**ADDENDUM NO.: 3**

**IFB or RFP NO.: 666**

Description: Furnish and Deliver a Split System  
Air Conditioner

Project: Queens College

Drawing Number: **M-900.00**

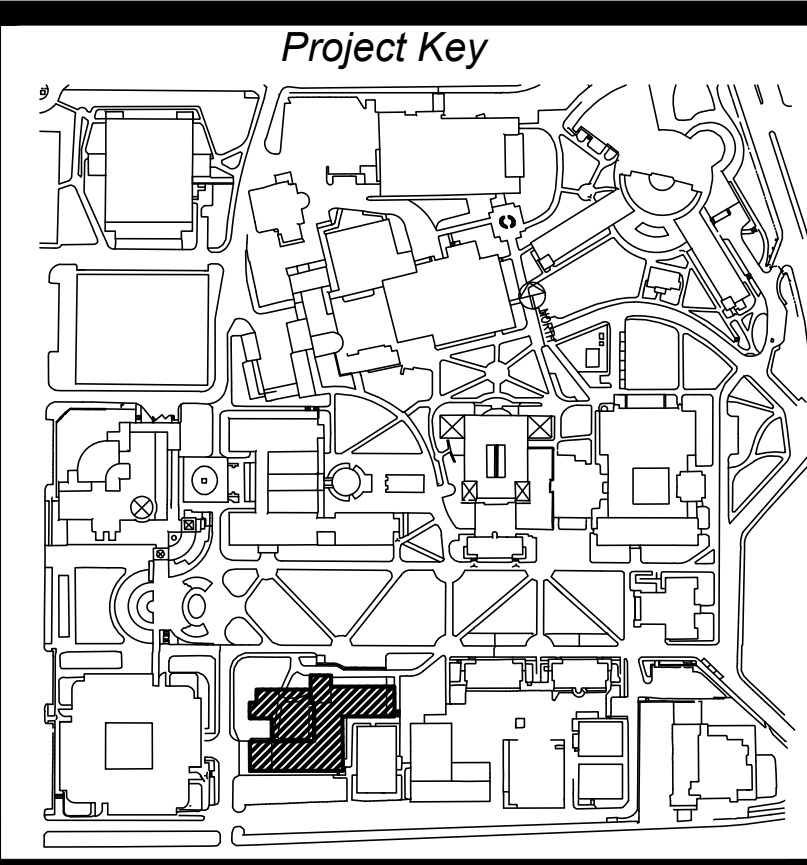
Specifics of the Addendum: Provide additional drawing.

Please refer to attached construction documents drawing M-900 for basic of design and system heating and cooling requirements. There are 4 rooms with their respective thermostats.
